UNITED STATES PATENT AND TRADEMARK OFFICE

APPLICATION NO.	FILING DATE	FIRST NAMED INVENTOR	ATTORNEY DOCKET NO.	CONFIRMATION NO.
10/820,495	04/07/2004	Kuo-Chih Lee	250119-1160	7405

Office Action Summary	Application No. 10/820,495	Applicant(s) LEE ET AL.	
	Examiner Wen-Ying P. Chen	Art Unit 2871

DETAILED ACTION

FIG. 5

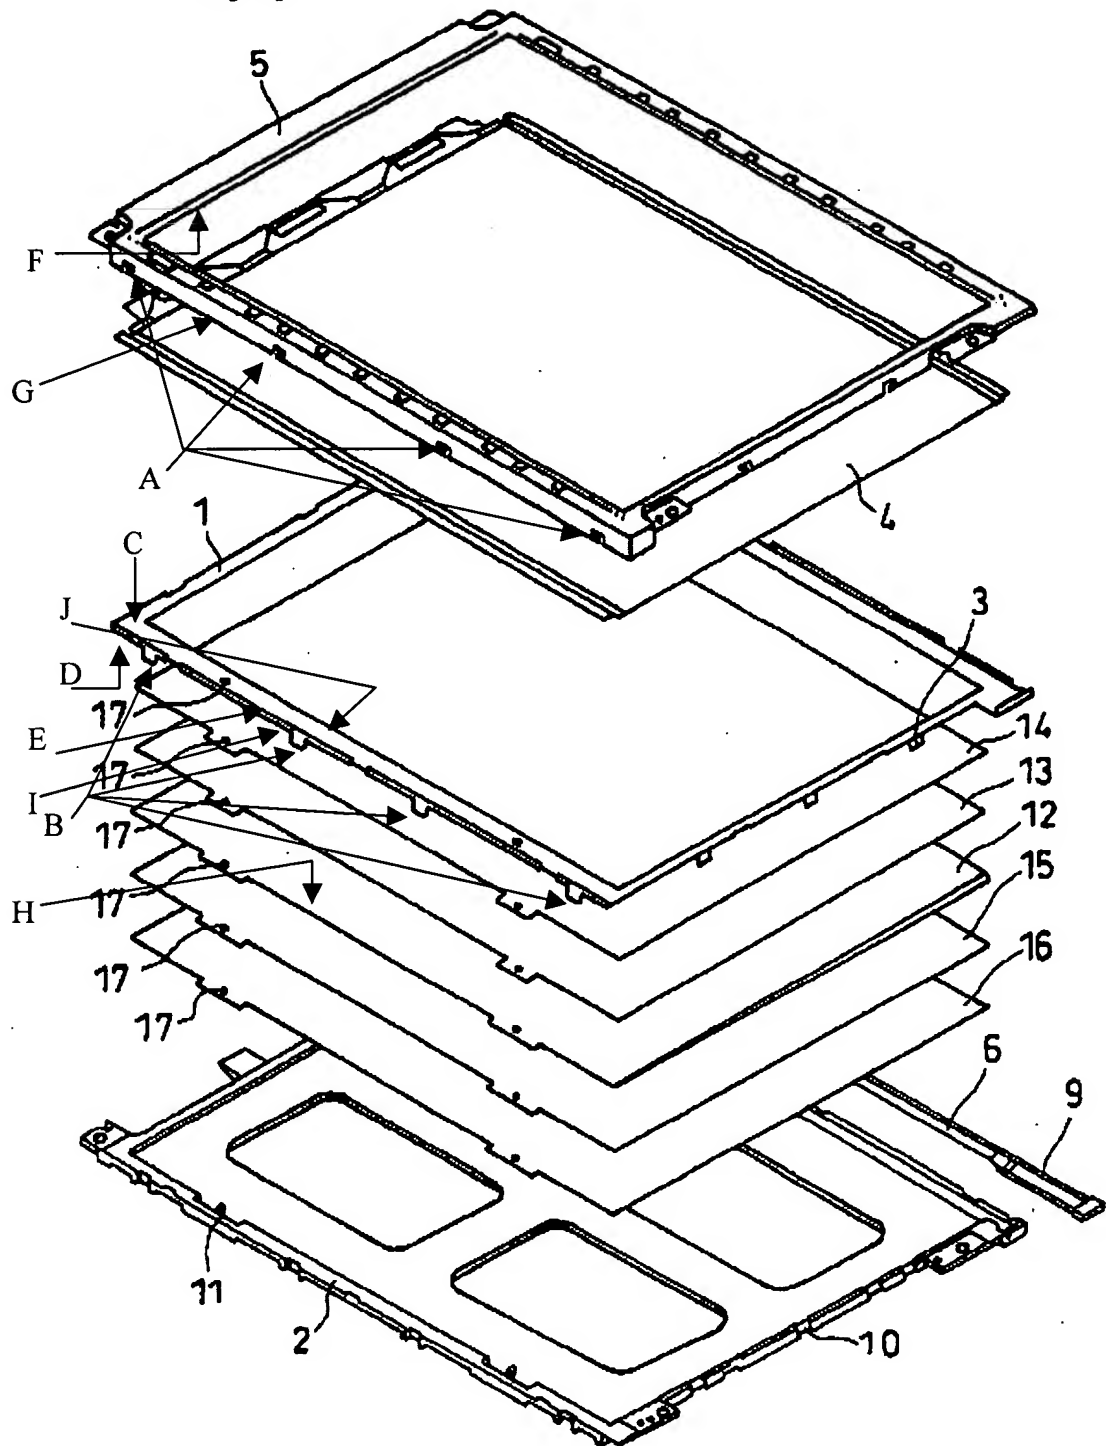
With respect to claim 1: Horiuchi et al. disclose in Figure 5 a liquid crystal display comprising: a front bezel (element 5) having a first fastened member (element A, as indicated in figure below); a frame (element 3) deposited below the front bezel; and a diffuser plate (element 12) deposited below the frame and having a second fastened member (element 17); wherein the frame has a first fastening member (element B, as indicated in figure below) with respect to the first fastened member and a second fastening member (element 17) with respect to the second

As to claim 2: Horiuchi et al. disclose in Figure 5 that the liquid crystal display further comprises a panel (element 4) disposed between the front bezel and the frame; wherein the panel is fastened between the front bezel and the frame while the first fastening member is coupled with the first fastened member.

As to claim 3: Horiuchi et al. disclose in Figure 5 that the liquid crystal display further comprises a multilayer optical film (elements 13 and 14) disposed between the frame and the diffuser plate; wherein the multilayer optical film is fastened between the frame and the diffuser plate while the second fastening member is coupled with the second fastened member.

As to claim 4: Horiuchi et al. disclose in Figure 5 that the liquid crystal display further comprises a panel (element 4) disposed between the front bezel and the frame; and a multilayer optical film (elements 13 and 14) disposed between the frame and the diffuser plate; wherein the frame comprises an upper surface (element C, as indicated in the figure below), a bottom surface (element D, as indicated in the figure below) and a side extending section (element E, as indicated in the figure below); the side extending section is perpendicular to the bottom surface; the first fastening member is disposed on the side extending section of the frame, and the second fastening member is disposed on the bottom surface of the frame; wherein the front bezel comprises a bottom surface (element F, as indicated in the figure below) and a side surface (element G, as indicated in the figure below); the side surface of the front bezel is perpendicular to the bottom surface of the front bezel and the first fastened member is formed in the side

surface of the front bezel; wherein the diffuser plate comprises an upper surface (element H, as indicated in the figure below) opposite to the bottom surface of the frame and the second fastened member is formed in the upper surface of the diffuser plate; the first fastening member and the second fastening member are respectively couple with the first fastened member and with the second fastened member simultaneously so that the front bezel, the panel, the frame, the multilayer optical film, and the diffuser plate are integrated as a whole.

As to claim 5: Horiuchi et al. disclose in Figure 5 that the frame further comprises an exterior edge (element I, as indicated in the figure below) and an interior edge (element J, as indicated in the figure below); the first fastening member is disposed on the exterior edge of the frame and the second fastening member is disposed on the interior edge of the frame.

As to claim 6: Horiuchi et al. disclose in Figure 5 that the front bezel comprises a bottom surface (element F, as indicated in the figure below) and a side surface (element G), the side surface (element E) of the frame is perpendicular to the bottom surface (element D) of the frame, the bottom surface of the front bezel is opposite to the upper surface of the frame (element C), the first fastened member is formed in the side surface of the front bezel; and wherein the diffuser plate comprises an upper surface (element H) opposite to a bottom surface of the frame and the second fastened member is formed in the upper surface of the diffuser plate.
